I-195 Washington Bridge (700)

Forensic Evaluation and Procedural Audit Related to PT Tie-Down Failures

DRAFT REPORT

April 5, 2024

Figure 18. Link Slab Detail, Sheet 45, RIDOT Contract 2016-CB-059, 2016.

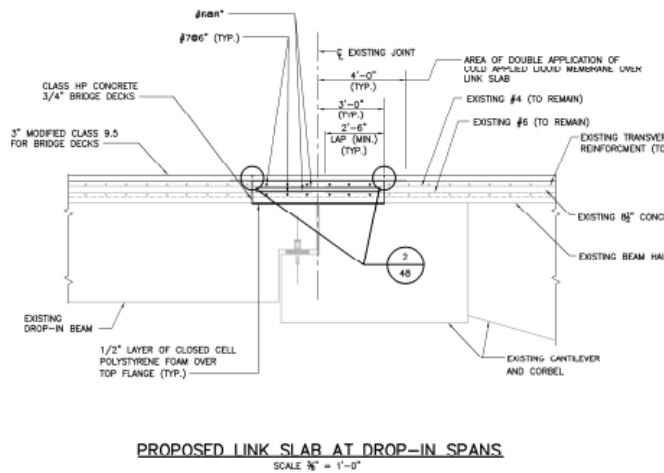
"A link slab is proposed where joints are proposed for elimination. With Scenario 2, the link slab detail would be constructed at 23 locations. A link slab is comprised of a reinforced concrete deck with a length that extends approximately 5% to 7% of each adjacent span. A bond breaker is applied between the slab and the top flange of the beam to prevent composite action in this region." Figure 18 reflects the detail issued for bid in the rehabilitation plans.

To accommodate the restraint added by the partial depth closure pours, the joints at the ends of the newly adjoined units were to be reworked to accommodate greater anticipated movement. Figure 19 shows the proposed detail for a strip seal at a drop-in-cantilever corbel support, for example.

Figure 24. Excerpt regarding Abutment 1 cantilever restraint from IFC Calculations²⁰

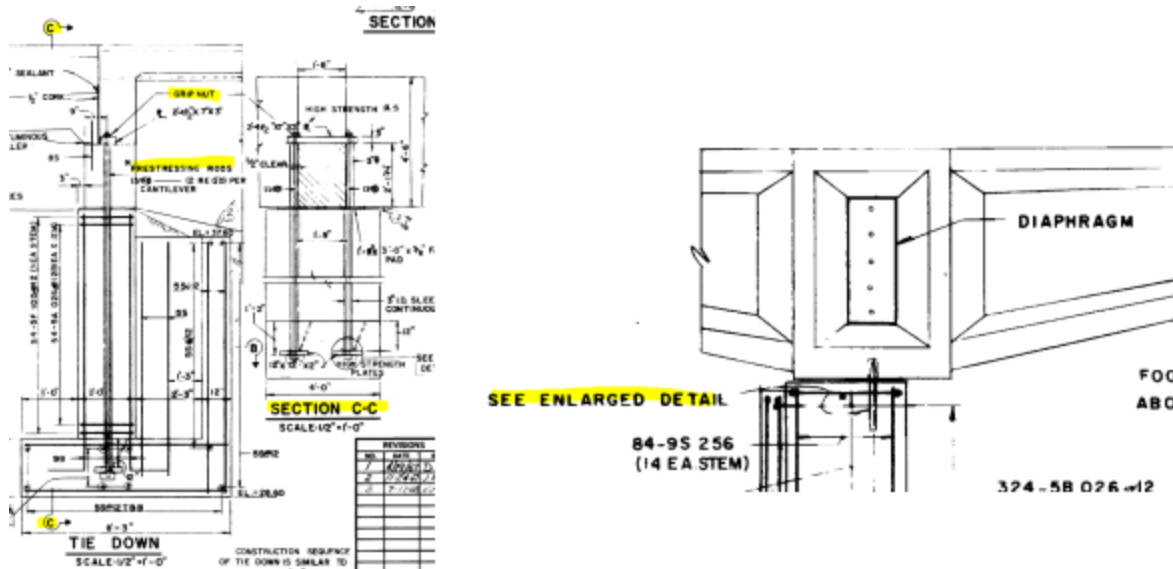
The west end of the PT beam located at Abutment 1 is restrained against uplift via a Tie Down detail consisting of prestressing rods cast into reinforced concrete and held in place by high strength steel plates attached to the rods via tightened nuts at either end. The result is a system that restricts lateral and vertical movement of the PT Beam end with respect to the supporting cantilever stem. Additionally, the base of the PT beam is restrained from moving laterally via a tapered steel down rod, but not significantly restrained against rotation.

Figure 24 was included as part of this passage and shows the Abutment 1 tie-down detail and the cantilever beam support and pintle detail (highlights by VHB). No similar discussion is presented in the IFC calculations for cantilever tie-down locations at Piers 6 and 7.

Ultimately, the AECOM joint elimination strategy was never implemented due to complications with the construction project and its cancellation. The concept was picked up by VHB under the "Phase 2" DB project issued in 2021. As noted, VHB's design did not adopt AECOM Scenario 2, which would have eliminated multiple joints in sequence along the bridge, instead opting to eliminate one of the two corbel joints in each cantilever/drop-in span. Thus, cumulative increase in thermal movement at joints at Pier 6 and Pier 7 were less than planned in the prior project. Nonetheless, VHB calculations do not reflect direct consideration of changes in thermal movement at the Pier 6 and Pier 7 joints on the cantilever tie-down rod detail. The calculation summary for the Abutment 1 connection states the girder end is free to rotate in all directions and free to translate in the Y (longitudinal) direction and only fixed in the X and Z (transverse and vertical) directions, which does not appear to be correct given the restraint of the tie-down rods.

Figure 37. Link slab placement timeline

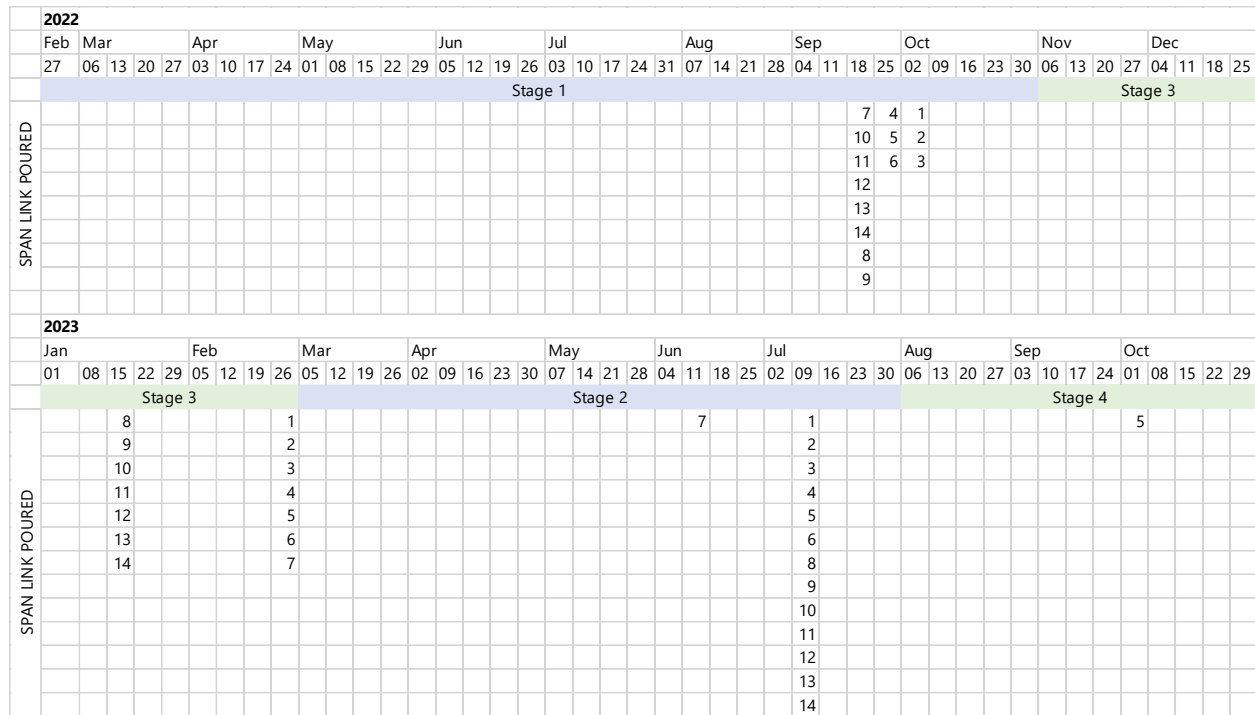
The two fractured rods were discovered during December 2023. The sequence of link slab closures is illustrated in the timeline of Figure 37. Specifically, closures for Span 6 (adjacent to Pier 6) occurred in September 2022, February 2023, and July 2023. Likewise, Span 7 closures (adjacent to Pier 7), occurred in September 2022, February 2023, and June 2023. The exact time of the fractures cannot be determined, but they were not observed during the July 2023 routine inspection. WJE's forensic evaluation noted that the thickness of corrosion product on the fractured surfaces suggests the fractures had not occurred very close to the time of discovery. However, it is likely fracture occurred within the timeframe that the link slabs were placed.
